Overview of Application for Authorization of Nuclear Reactor Installation Change Following Change of Solidifier in Radioactive Waste Solidifying Equipment at Hamaoka Nuclear Power Station

Chubu Electric Power Co., Inc. has chosen to switch from plastic to cement as the solidifier in its radioactive waste solidifying equipment, and to obtain authorization from the national government for this change, it submitted to the Minister of Economy, Trade and Industry today (October 16, 2009) an “Application for Authorization of Nuclear Reactor Installation Change at Hamaoka Nuclear Power Station (Change of Nuclear Reactor Facilities Nos. 1 - 5)” as based on the Act on the Regulation of Nuclear Source Material, Nuclear Fuel Material and Reactors. The following is an overview of the application.

■ Sketch of change to radioactive waste solidifying equipment (Fig. 2)

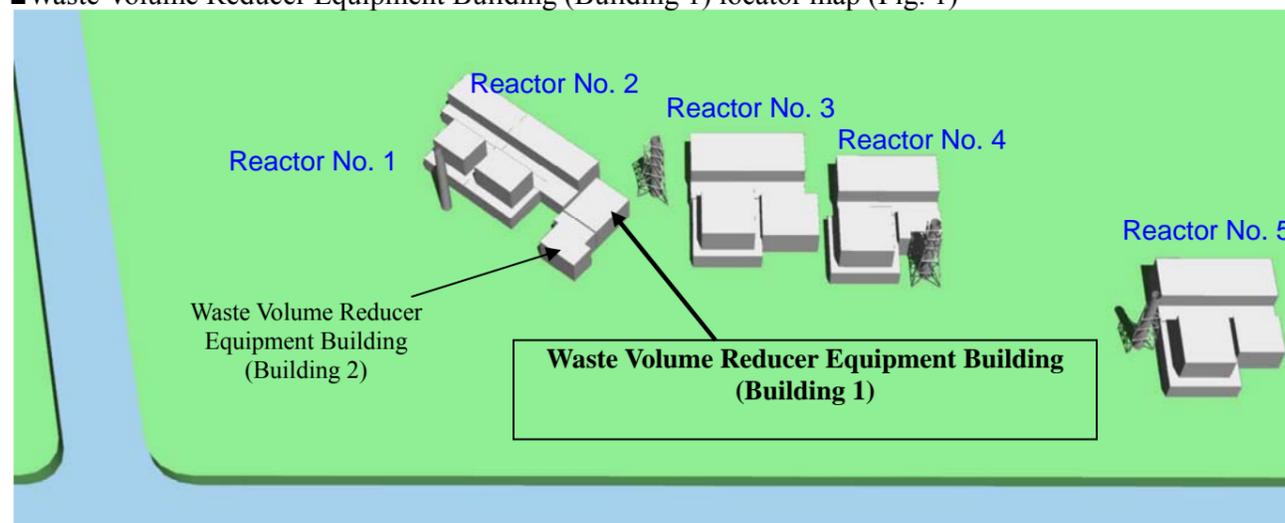
More than 20 years have passed since the radioactive waste solidifying equipment was installed in 1985. Some of the control components, electric components, and so on are due to be replaced, and to coincide with the update of this equipment, we are switching the solidifier from plastic, which we have used up to now, to cement, which is easy to handle^{*3}. (Fig. 2)
